CITY of NOVI CITY COUNCIL

Agenda Item C
March 25, 2013

SUBJECT: Approval of the request of TRM Architecture for The Cheesecake Factory for Preliminary Site Plan and Section 9 Façade Waiver approval. The subject property is located in Section 14 at 27500 Novi Road within the Twelve Oaks Mall in the RC, Regional Center District. The applicant is proposing to modify the existing façade and outdoor eating area of Space E-121 in the Twelve Oaks Mall.

Re: **FACADE ORDINANCE - Facade Review – Preliminary Site Plan**
12 Oaks Tenant Space E-121, PSP13-0044
 Façade Region: 1, Zoning District: RC, Building Size: 9,400 S.F.

A2.0

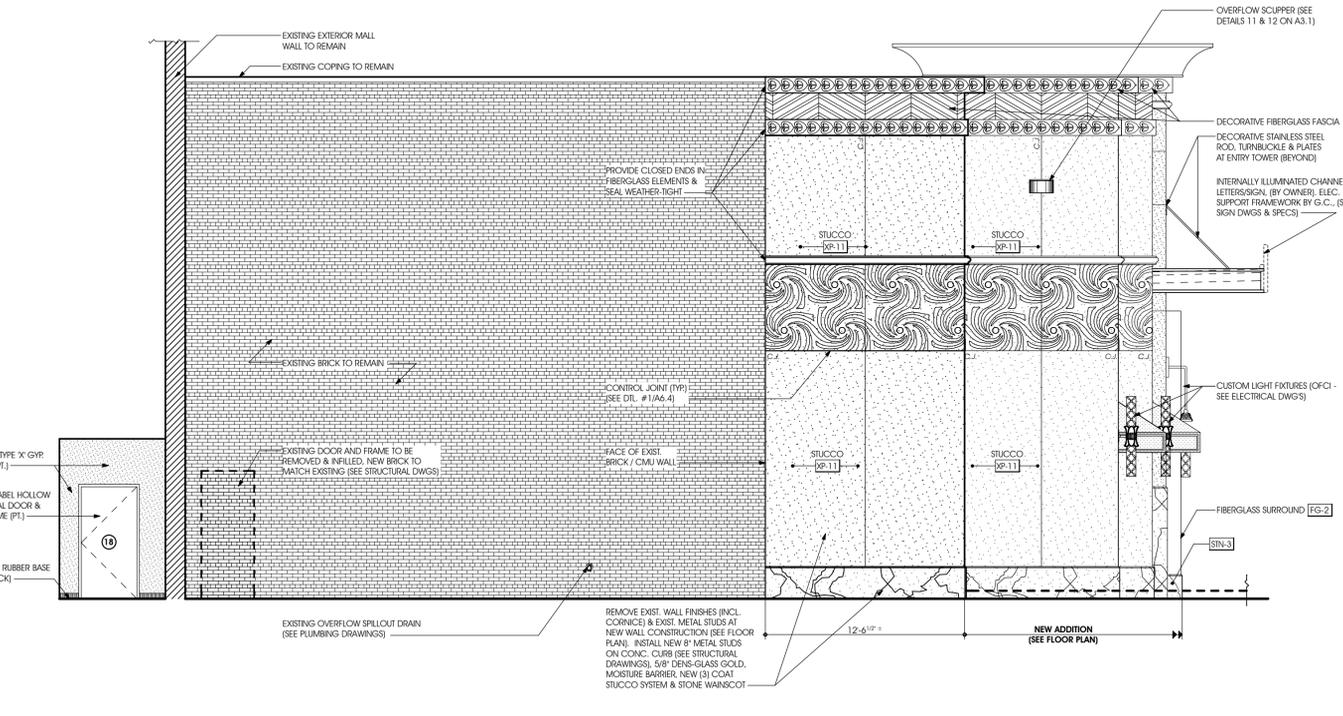
It is noted that minor inconsistencies were found between the elevation drawings (Sheet A2.0) and the rendering; STN-1 is shown on the drawing vs. STN-2 on rendering. The notations found on the rendering were believed to be correct and were used for this review. The applicant should clarify that these assumptions were correct.

As shown above in the table above the minimum percentage of Brick is not provided on the east façade and the proposed percentage of EIFS exceeds the maximum amount allowed on the east façade. A Section 9 Waiver would be required for the deviations from the Façade Chart.

It is noted that minor inconsistencies were found between the elevation drawings (Sheet A2.0) and the rendering; STN-1 is shown on the drawing vs. STN-2 on rendering. The notations found on the rendering were believed to be correct and were used for this review. The applicant should clarify that these assumptions were correct.

As shown above in the table above the minimum percentage of Brick is not provided on the east façade and the proposed percentage of EIFS exceeds the maximum amount allowed on the east façade. A Section 9 Waiver would be required for the deviations from the Façade Chart. [It is the intent to pursue a facade waiver.](#)
